ADDENDUM NO. 1

HAMEHOOK RD BRIDGE #17C32 REPLACEMENT

The Bidding Documents for the HAMEHOOK RD BRIDGE #17C32 REPLACEMENT project are amended as follows:

DRAWING NO.
 18 OF 28
C4.0

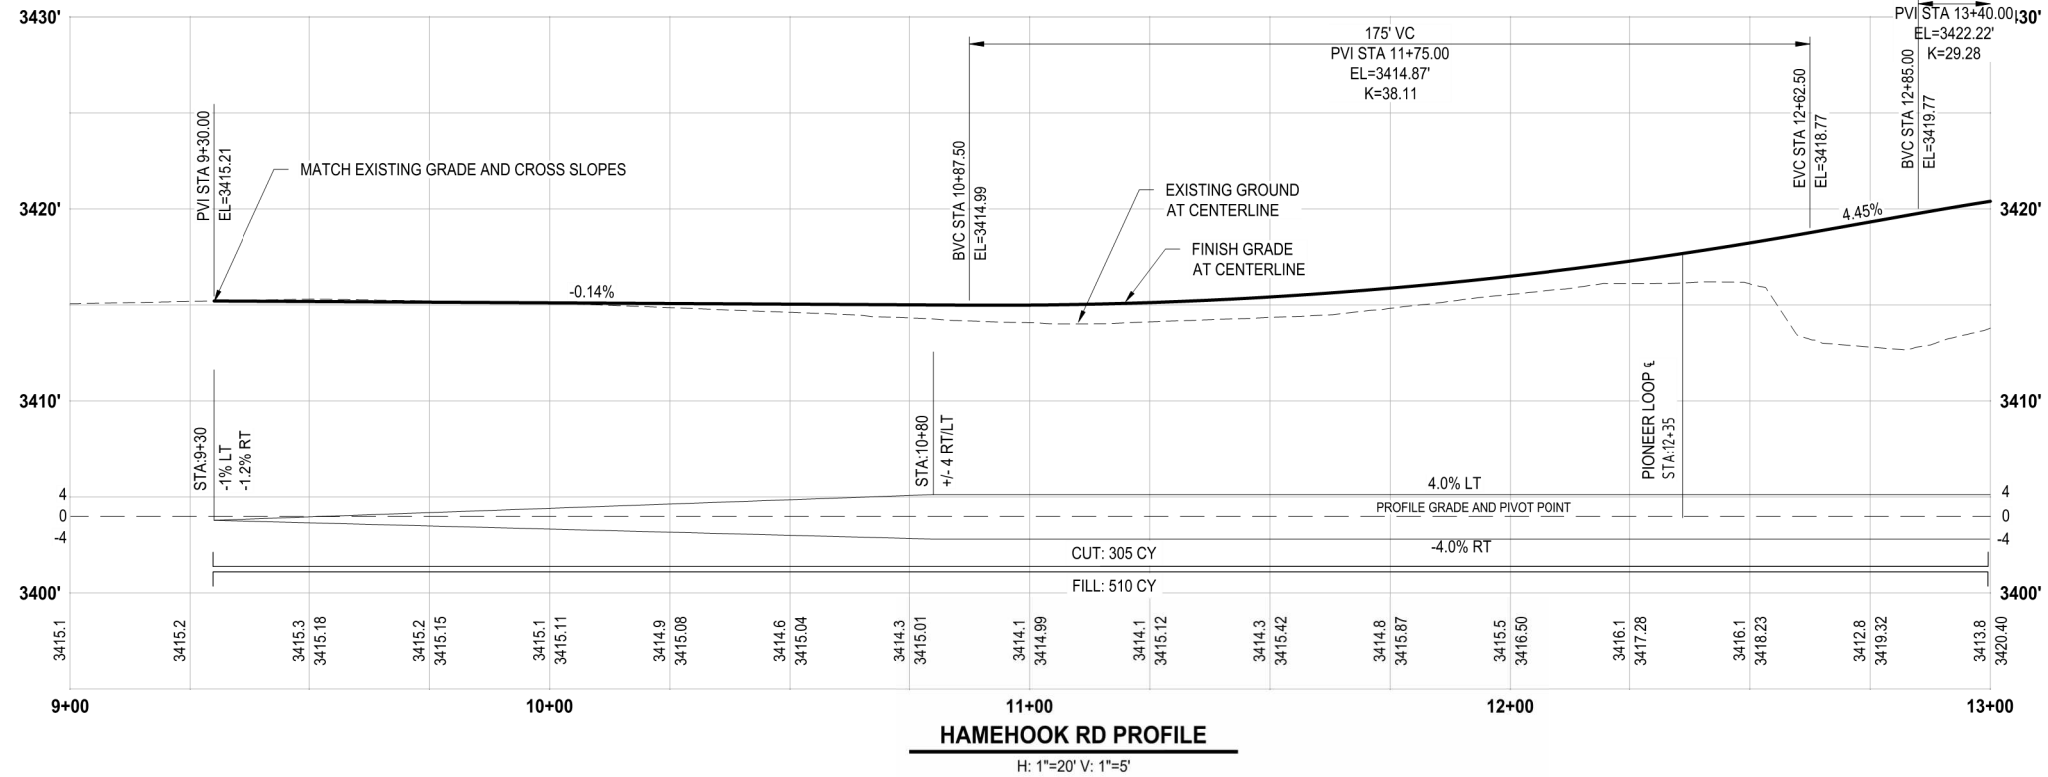
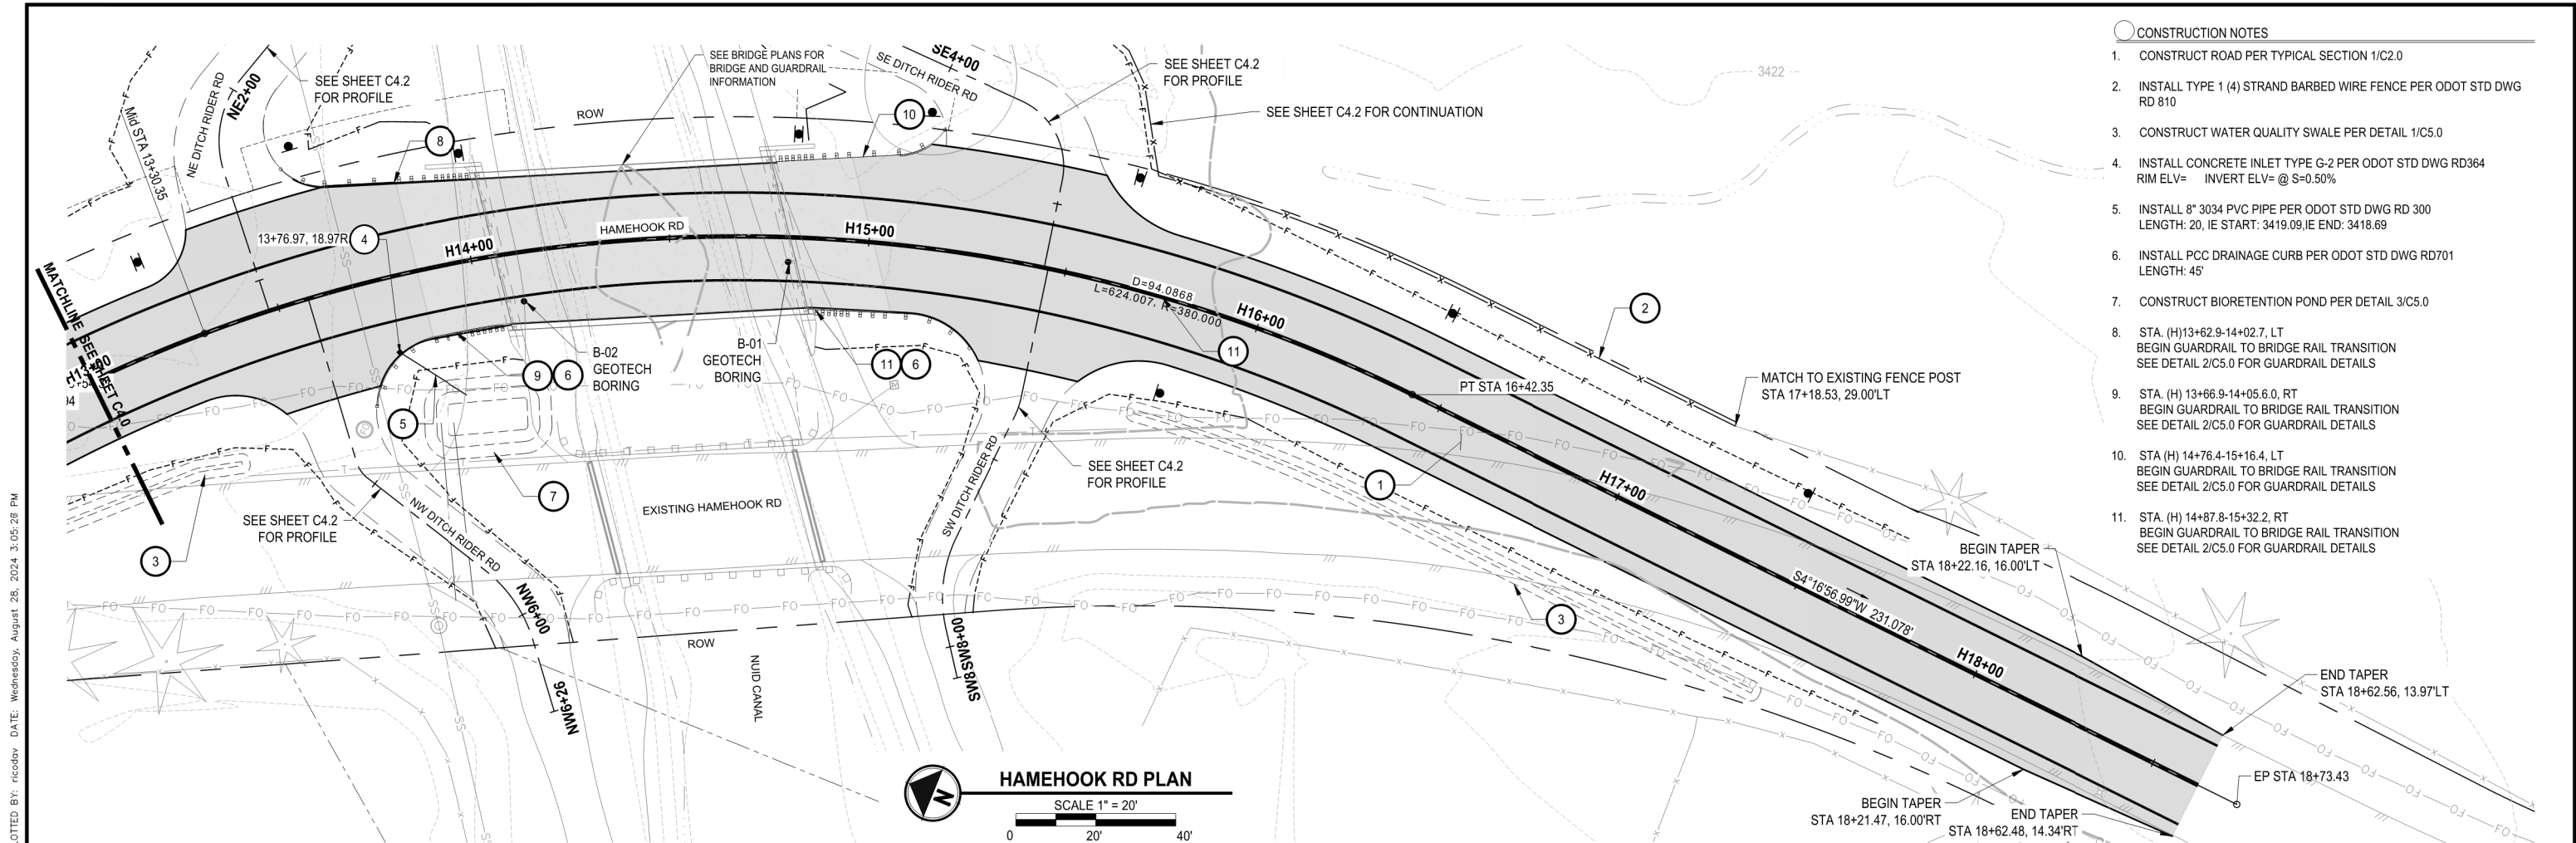
- ***Replace Plan Sheets C4.0 through C4.3 with the attached.***
 - Cut/Fill volumes are now included in the Profile View on each sheet.
